Agenda Date: 11/16/2020

Agenda #: 3. **File #:** 15-14591 **Type:** Zoning Decision

Rezoning Petition: 2019-085 by American Asset Corporation

Zoning Committee Recommendation

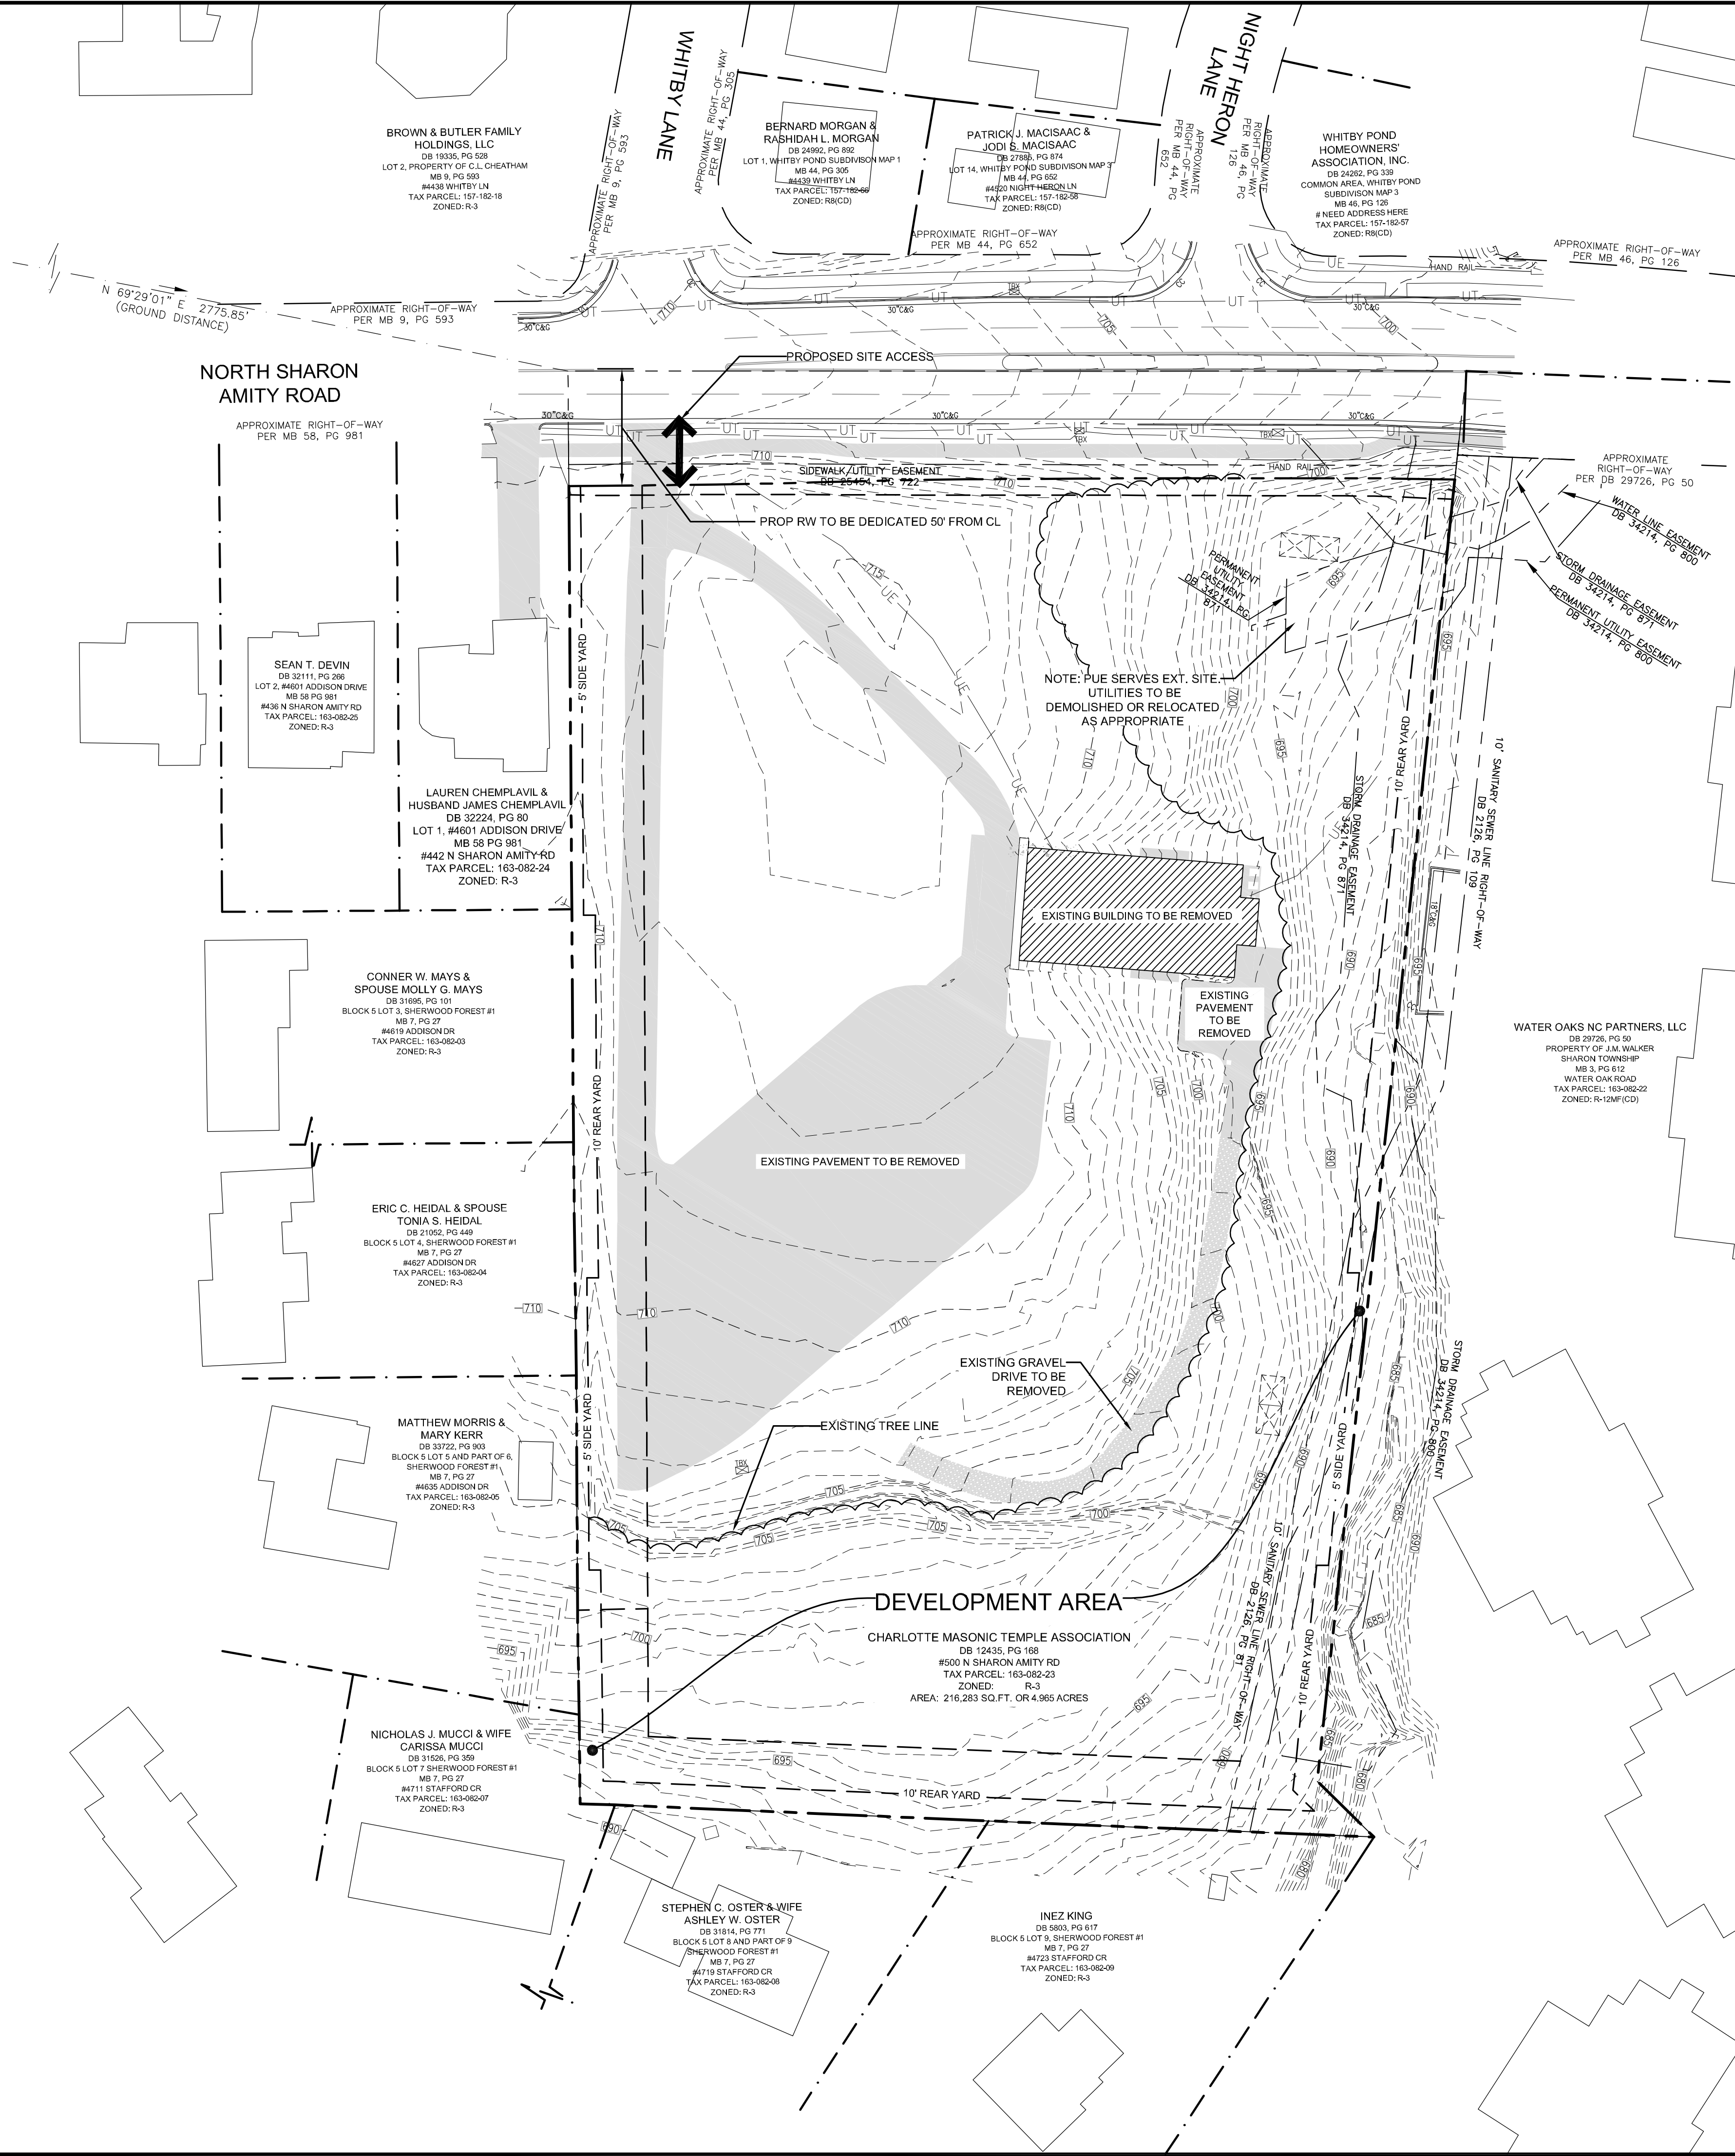
- Specifies architectural standards related to allowed façade materials, blank walls, raised entrances, prominent pedestrian entrances, usable porches and stoops and pitched roofs.
